-01 Fuselage Tail Cone Assembly

sonex-B
Fuselage Tail Cone Assembly

Drawing Scale	Drawing Number	Revision
1/8 & Noted	SNB-F18	E

Detail A
Scale: 1/2
Typical Right and Left Sides

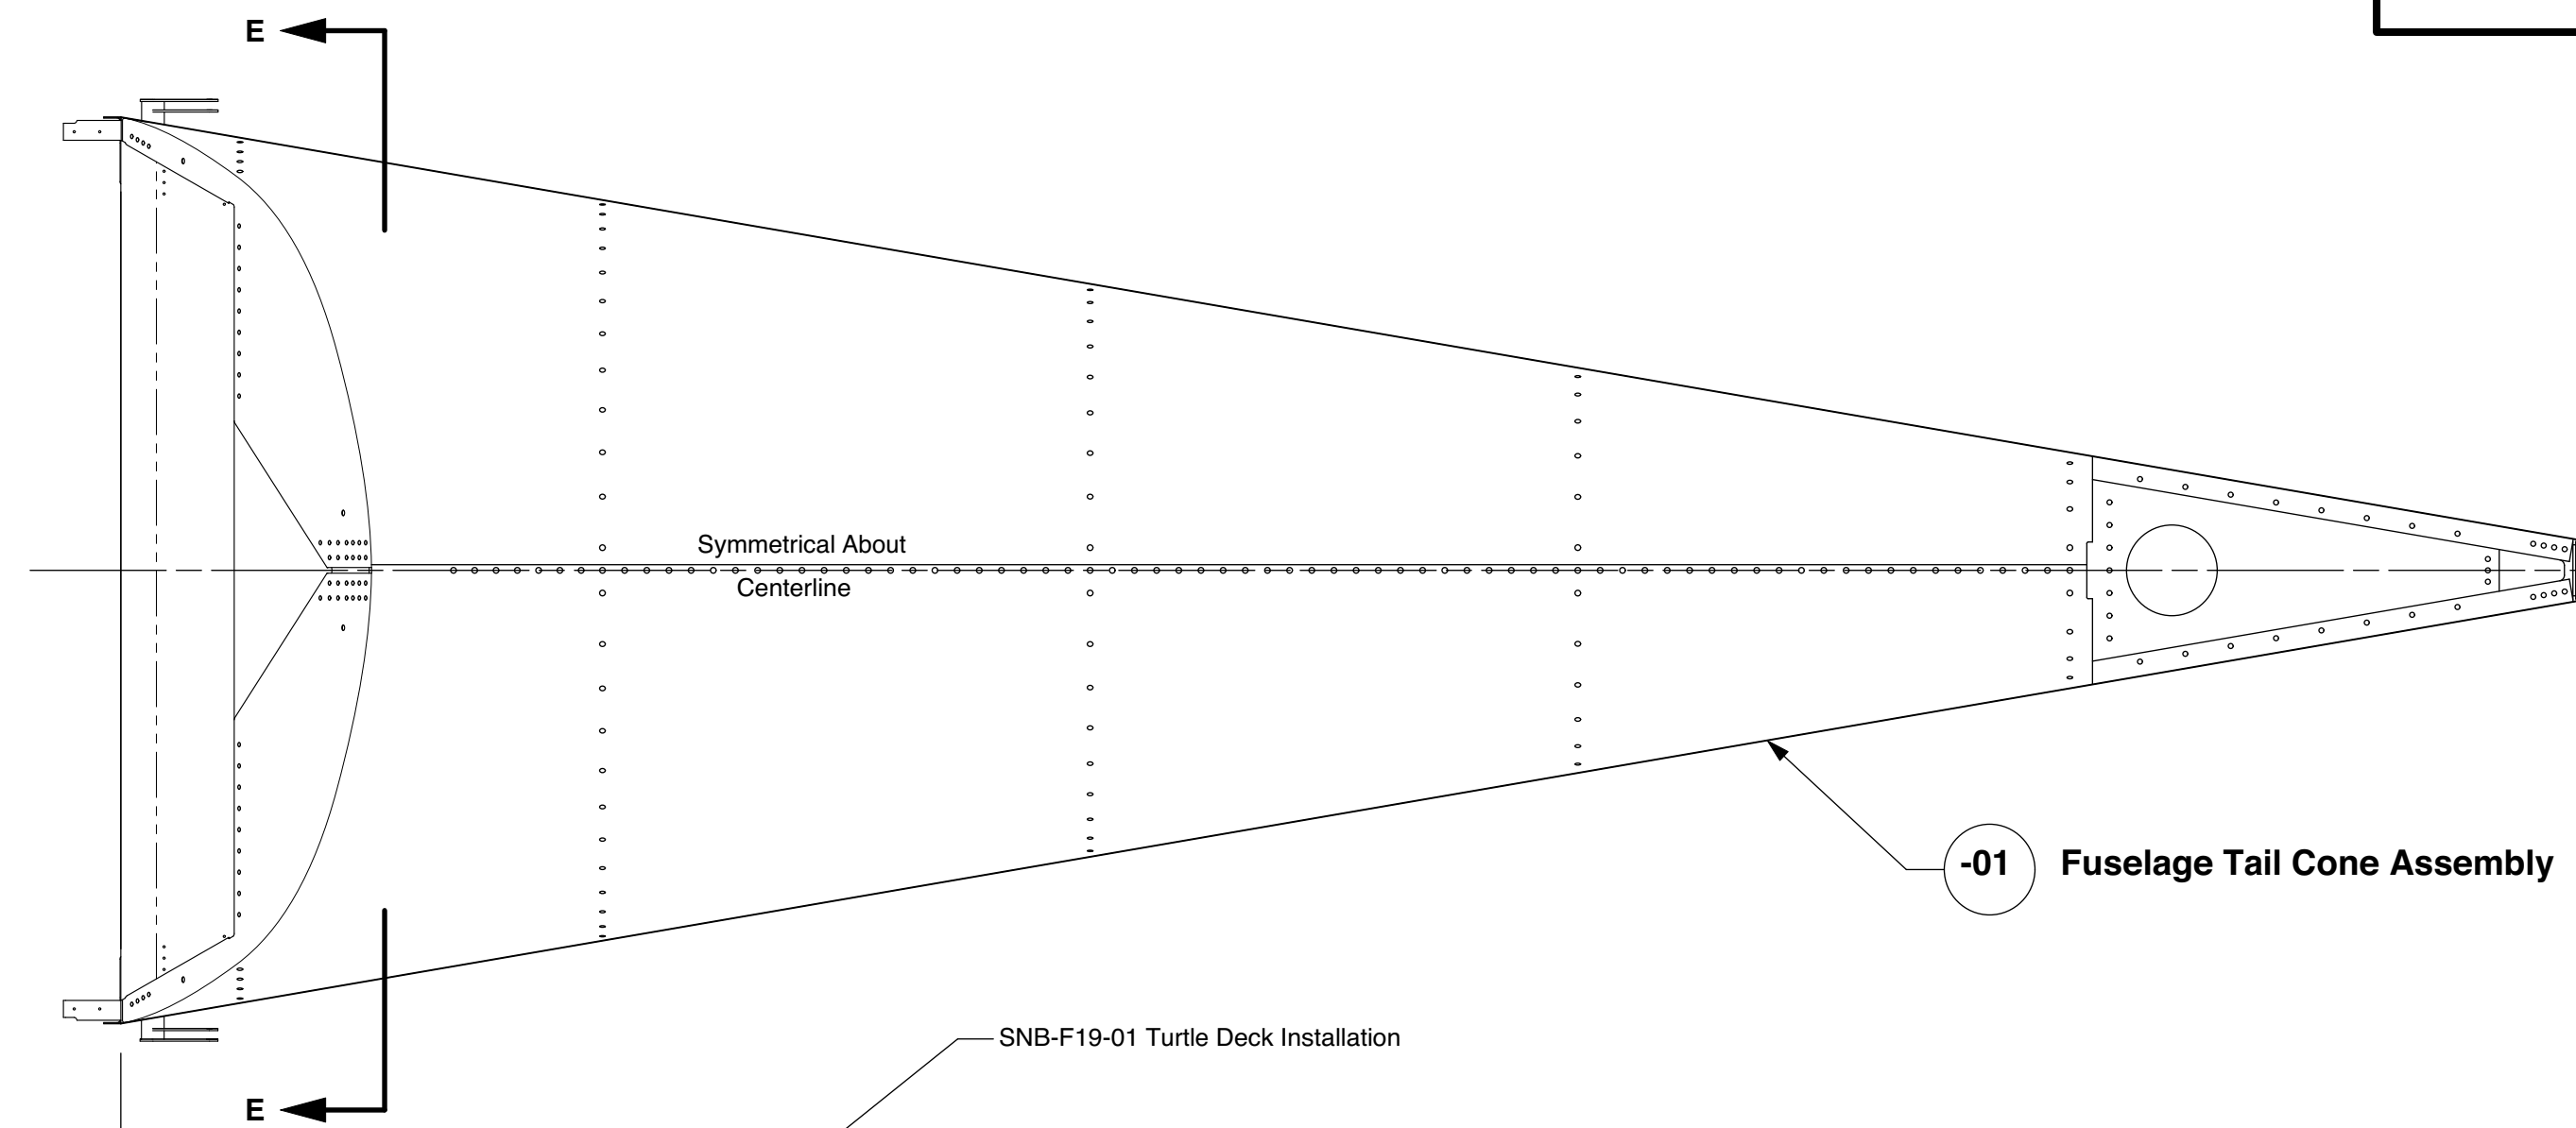
Revision Letter	Change Description	08/24/16
A	Changed AN525-10R12 bolts through splices and forward lower mount angle to AN525-10R11, and added AN960-10 Washers.	02/10/21
B	Changed from SNB-F18-02L/R flap actuator mounts to SNB-F18-03L/R feedback actuator mounts for use with feedback-type actuators equipped with potentiometers.	02/12/21
C	Added Notes to View E-E and Detail F to Back-Rivet Actuator Mounts From Interior of Cross-Tie Box.	02/15/21
D	Detail A: AN525-10R12 Bolt was AN525-10R11.	12/19/22
E	Changed from SNB-F18-03L/R flap actuator mounts to SNB-F18-04L/R actuator mounts for use with SNB-C05-11 Flap Actuators, shipped for kits beginning in 2022. Eliminated View E-E, Detail F, and Detail G.

AN525-10R12 Bolt, 4 Required (2 per side)
AN960-10 Washers, 4 Required (2 per side)
AN365-1032 Nut, 4 Required (2 per side)
Thru Fuselage Side Skin, Turtle Deck Skin, Longerons and Splice Plate.
